Georgia State Amendments to the Standard Building Code (2000 Edition)

Revised January 1, 2005

**GEORGIA STATE MINIMUM
STANDARD BUILDING CODE
(INTERNATIONAL BUILDING CODE)**

**FIGURE 1615(11)
MAXIMUM CONSIDERED EARTHQUAKE GROUND MOTION FOR GEORGIA OF 0.2 SEC
SPECTRAL RESPONSE ACCELERATION (5 PERCENT OF CRITICAL DAMPING), SITE CLASS B**

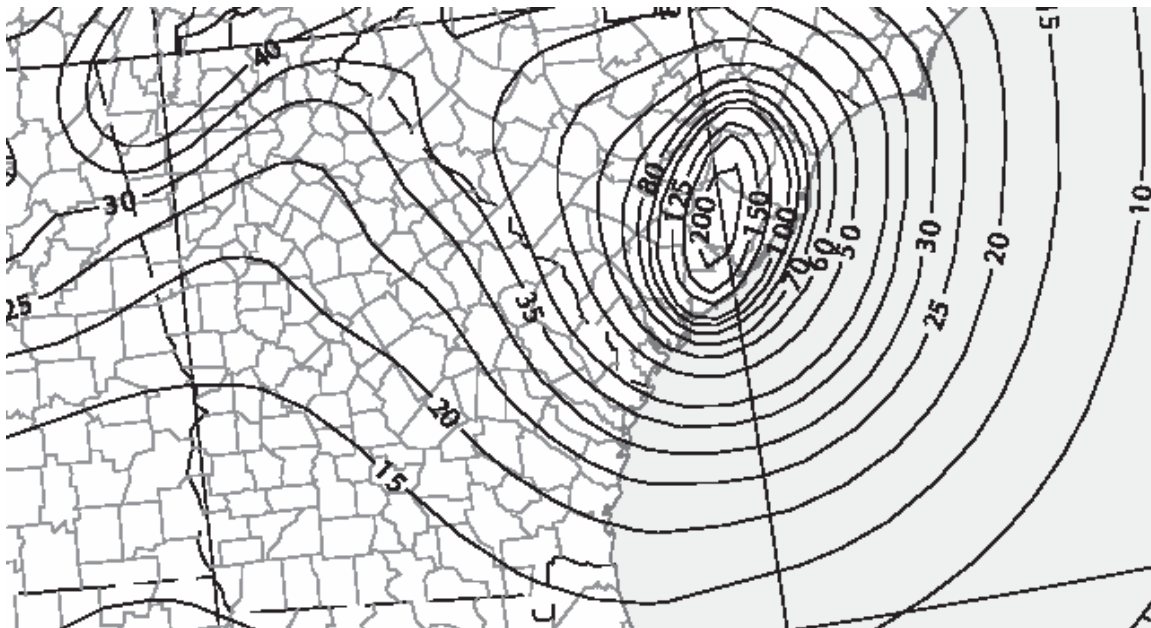
*Revise Section 1615.1 ‘General procedure for determining maximum considered earthquake and design spectral response accelerations’ to add exception and two new figures.

As an alternate Figures 1615(11) and 1615(12) shall be permitted to be used in Georgia.
(Effective January 1, 2005)
